MONTGOMERY COUNTY HISTORIC PRESERVATION COMMISSION
STAFF REPORT

Address:	9 Hesketh St., Chevy Chase	Meeting Date:	10/25/17
Resource:	Contributing Resource Chevy Chase Village Historic District	Report Date:	10/18/17
Applicant:	Paul Berman	Public Notice:	10/11/17
Review:	HAWP	Tax Credit:	n/a
Case Number:	35/13-17JJ	Staff:	Dan Bruechert
Proposal:	Window Replacement

EXTERIOR ELEVATIONS
1/4" = 1'-0"

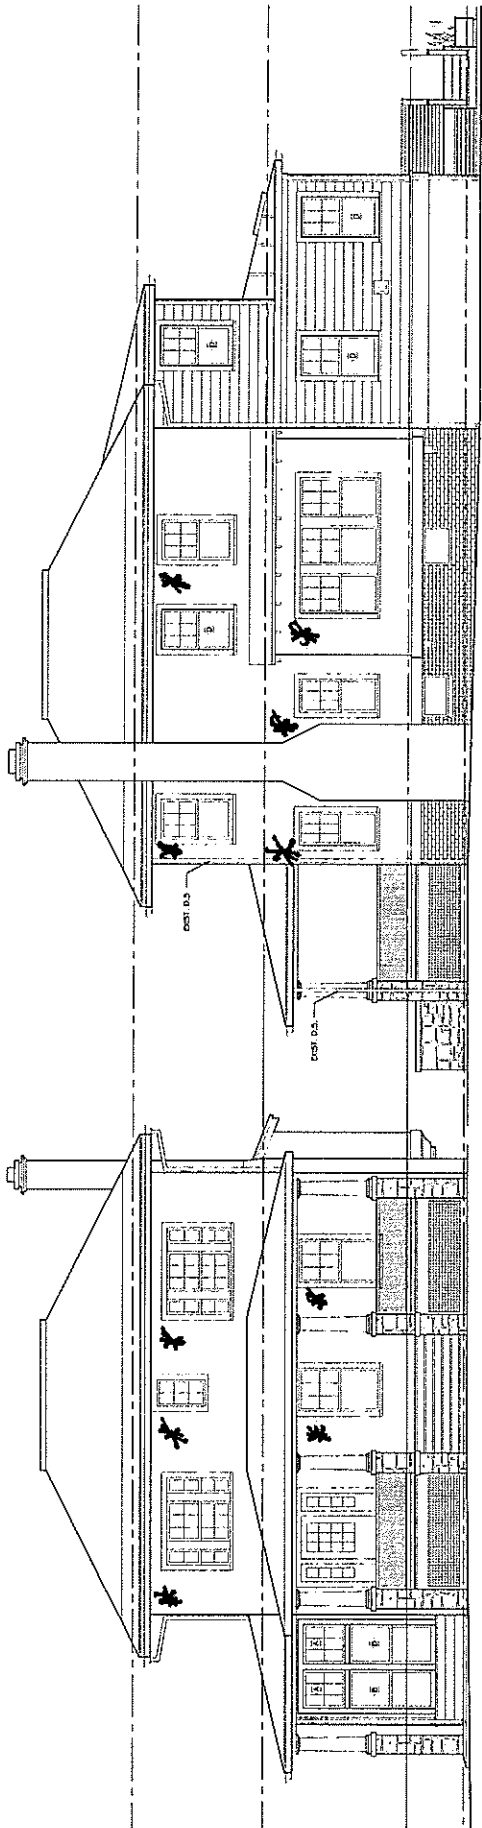
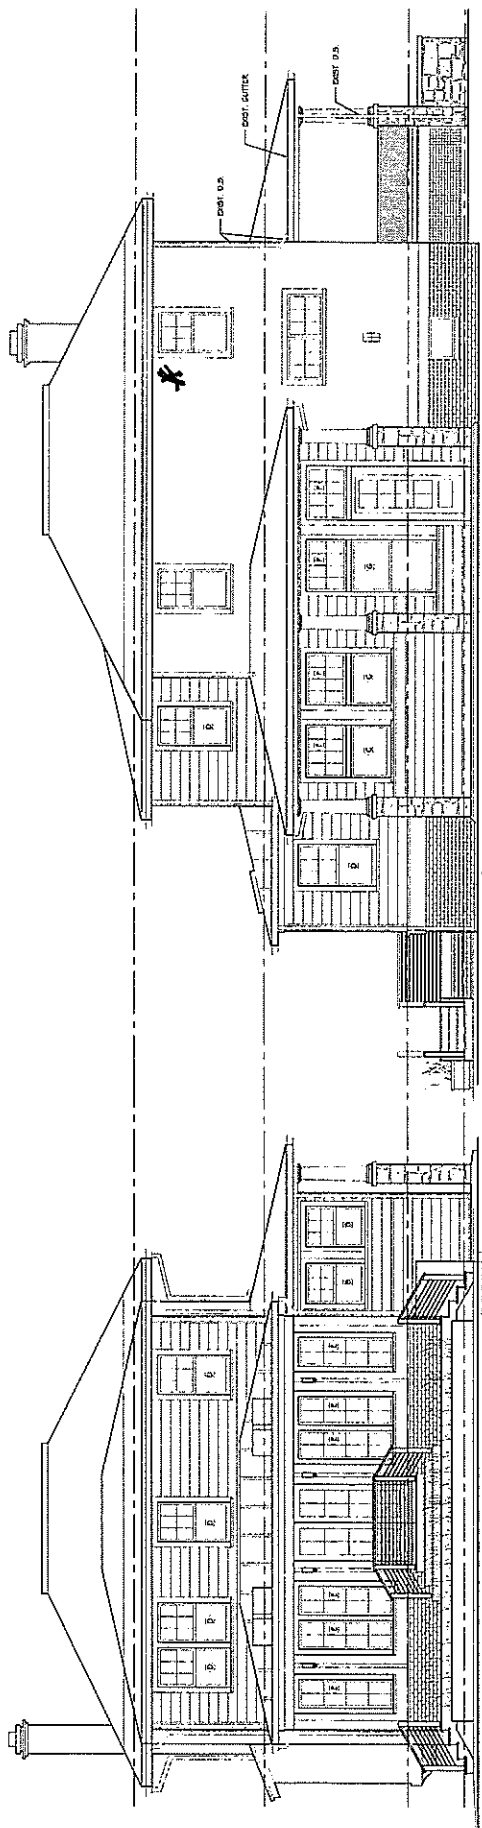
The applicant is proposing to remove eighteen (18) historic wood windows and replace them with Pella Architect series aluminum clad windows in a matching configuration. The specifications provided by the contractor indicate that only sixteen windows will be installed. Staff has reached out to the applicant for clarification, however, the number of windows replaced does not change the analysis of the appropriateness of the window replacement. Staff will update the HPC upon receipt of clarification.

The proposed windows are double-hung and custom sized to fully fit the historic opening. They will match the configuration of the historic windows and the 7/8" (seven-eighth inch) fixed grids will have a putty bevel profile on the exterior and an ogee-profiled interior. This is consistent with the appearance of a historic wood window. Staff feels that these details are sufficient to pass the moderate scrutiny required by the *Design Guidelines* and recommends approval for the replacement windows.

1. The applicant must clarify the number of windows proposed for removal and replacement prior to stamping the plans with final approval authority delegated to Staff.
